TO: Brian Wilson, CVL Consultants of Colorado, Inc.

FROM: Stacey Nerger, Associate Planner

SUBJECT: Trails at Crowfoot Filing No. 1 – Final Plat
[Application SUB17-039]

TRAILS AT CROWFOOT FILING NO. 1

A PART OF THE SECTIONS 4, 8 AND 9, TOWNSHIP 7 SOUTH, RANGE 66 WEST OF THE 6th PRINCIPAL MERIDIAN,
TOWN OF PARKER, COUNTY OF DOUGLAS, STATE OF COLORADO
SHEET 12 OF 17

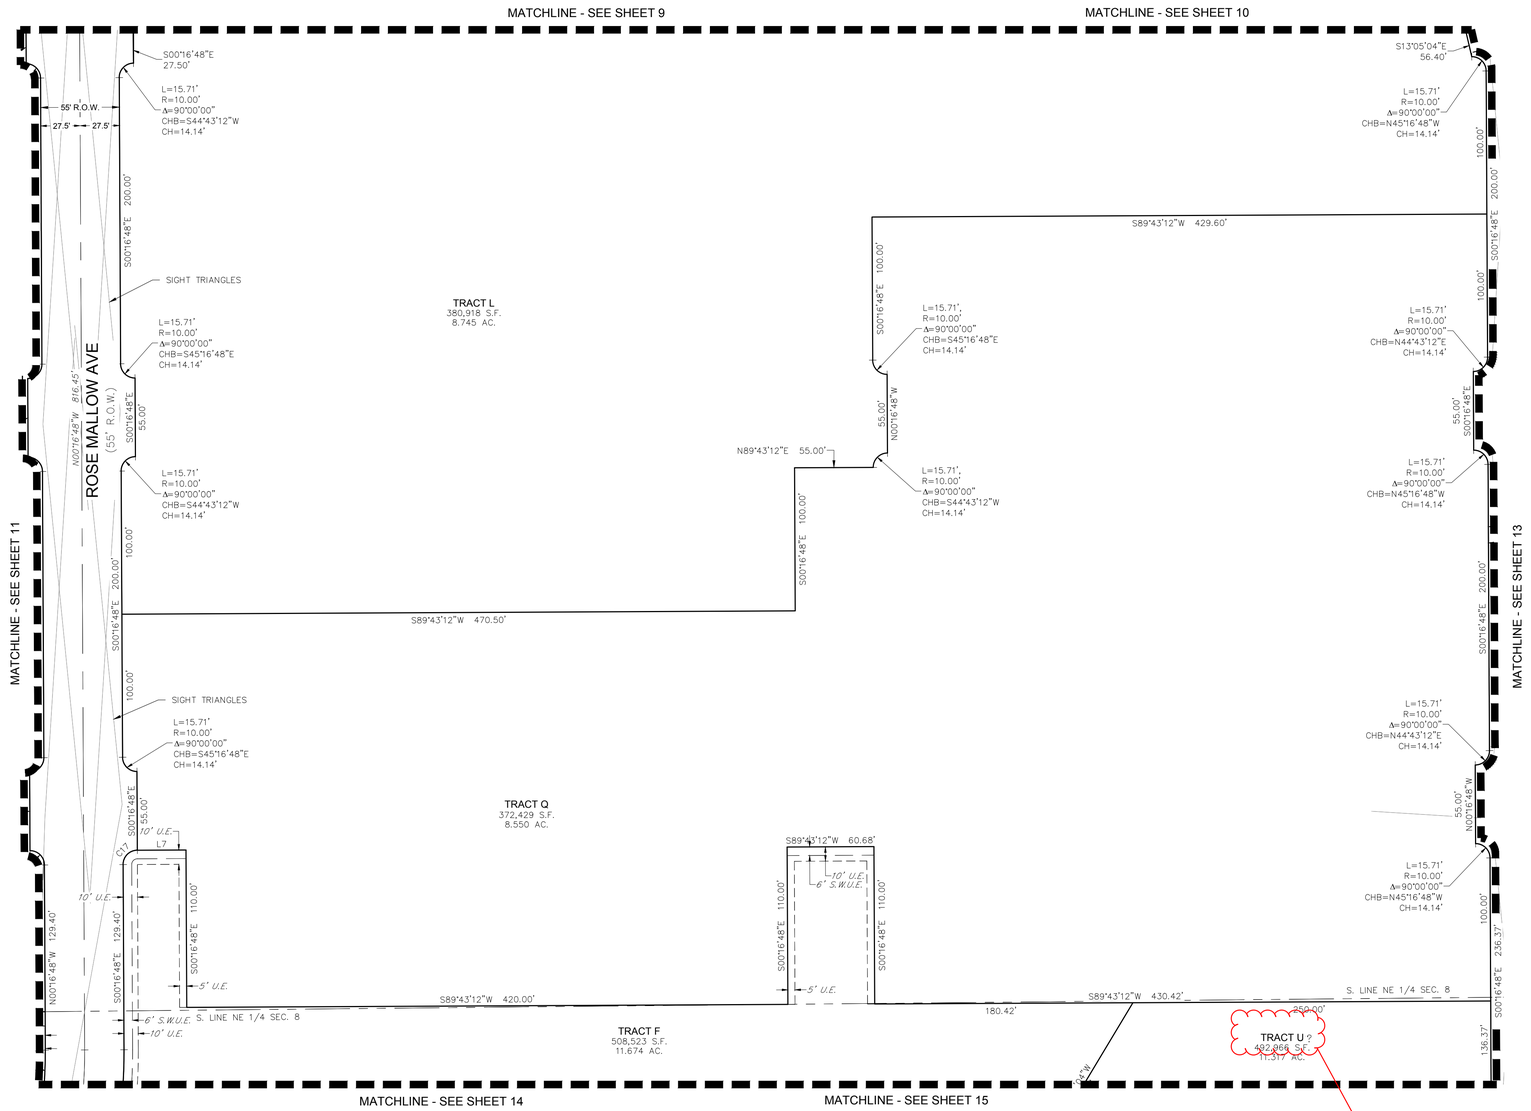
What is the question mark for?

■ Sheet Number ■
L1.1

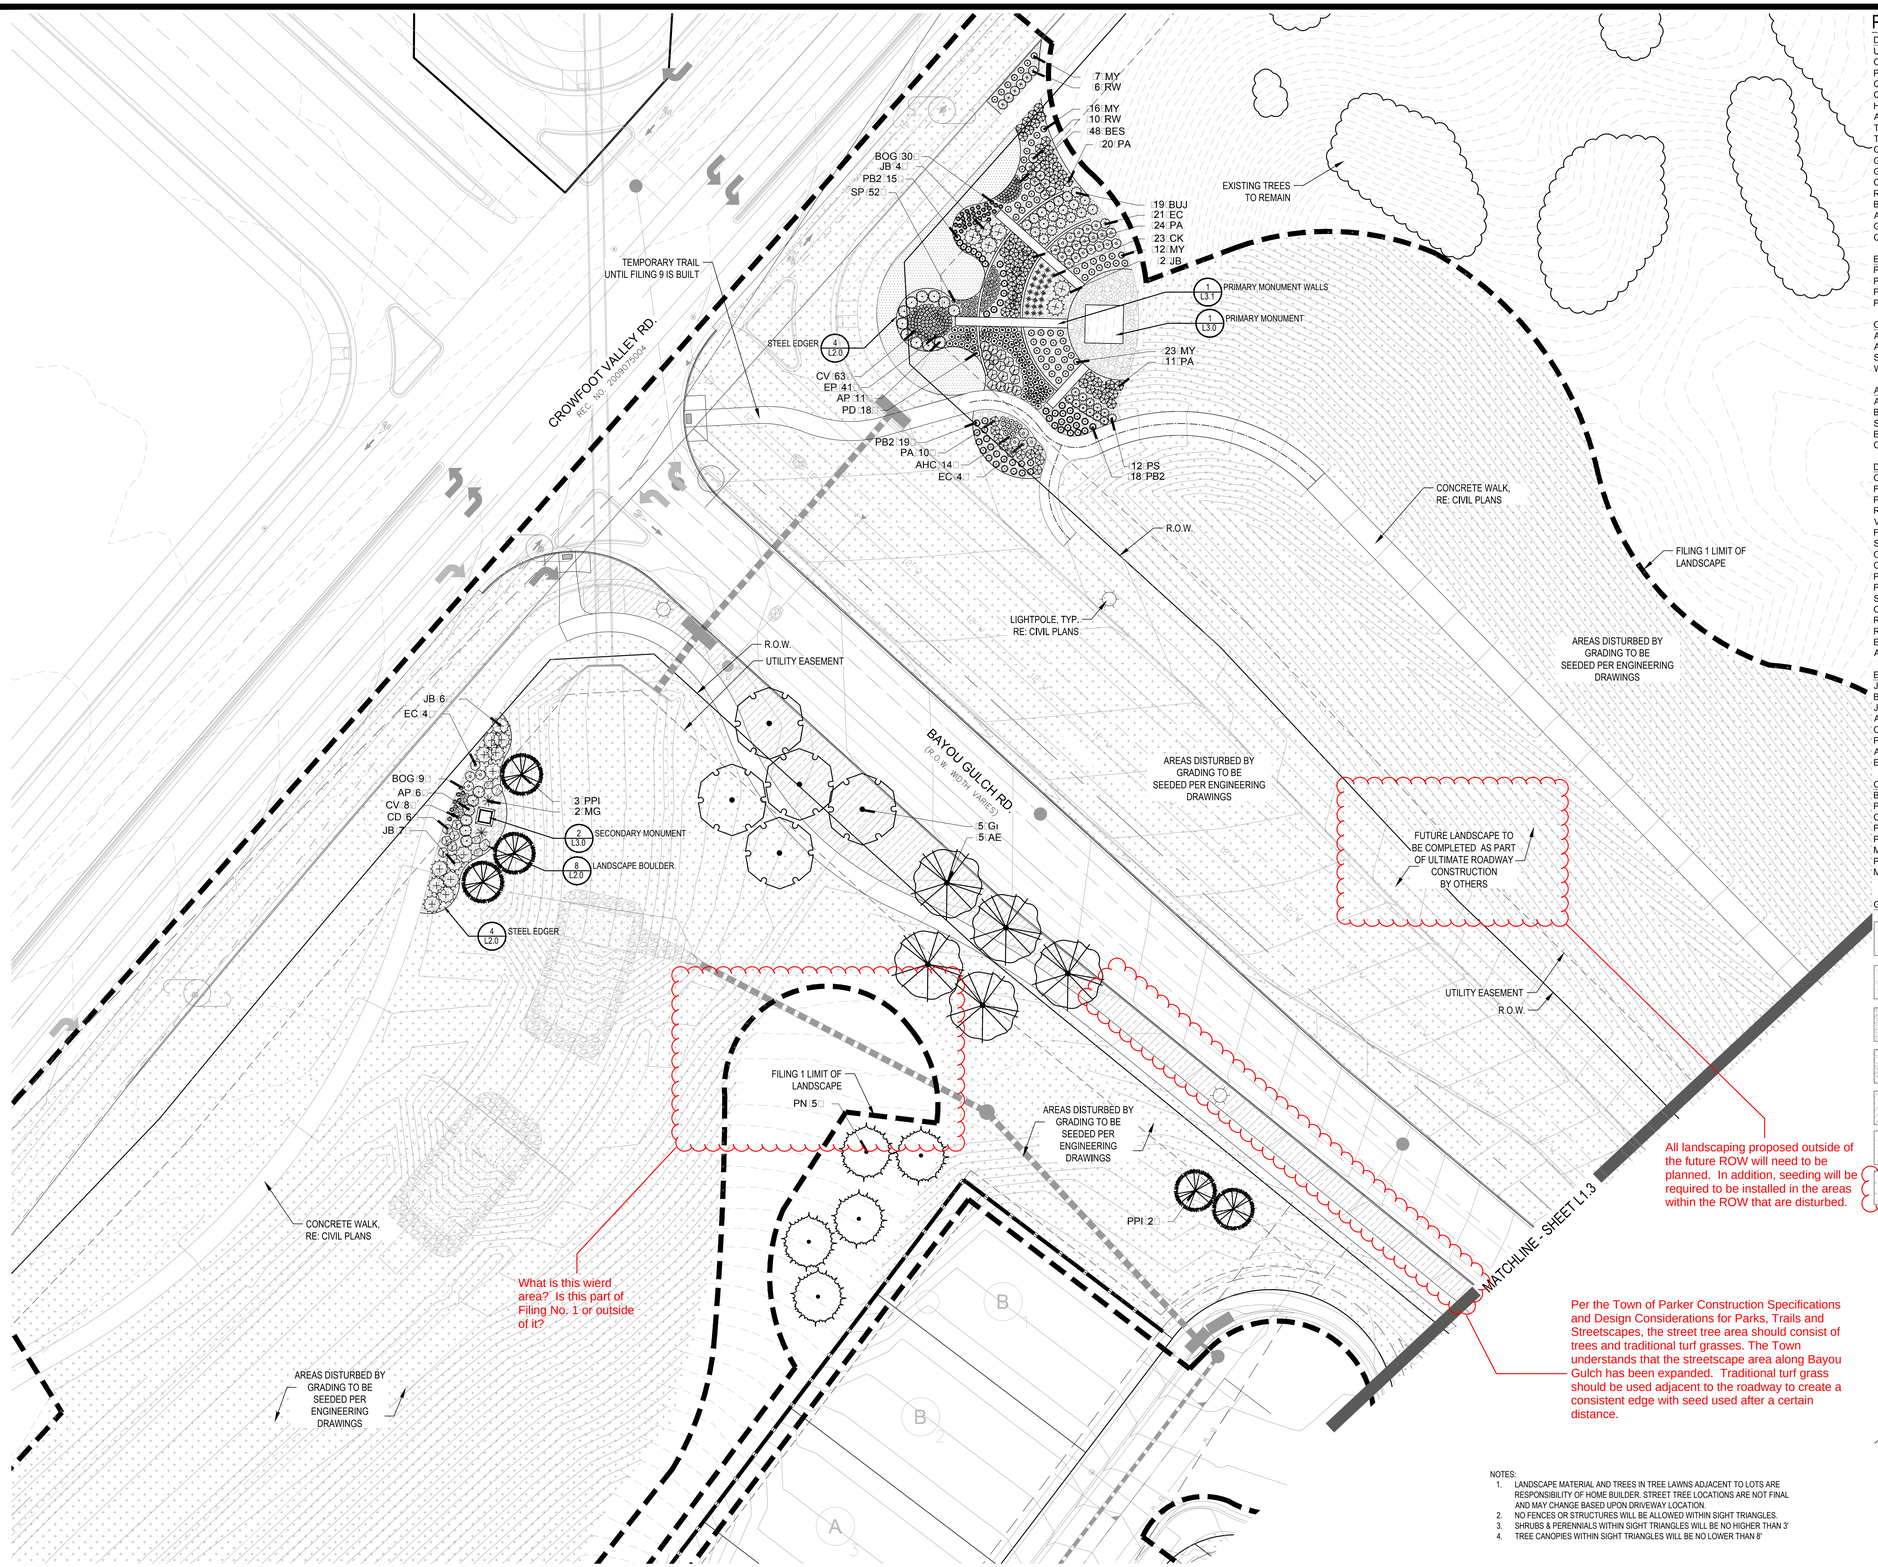
Please add a label identifying the type of trail with width and construction material.

Please see previous page for note to be added regarding natural state vegetation.
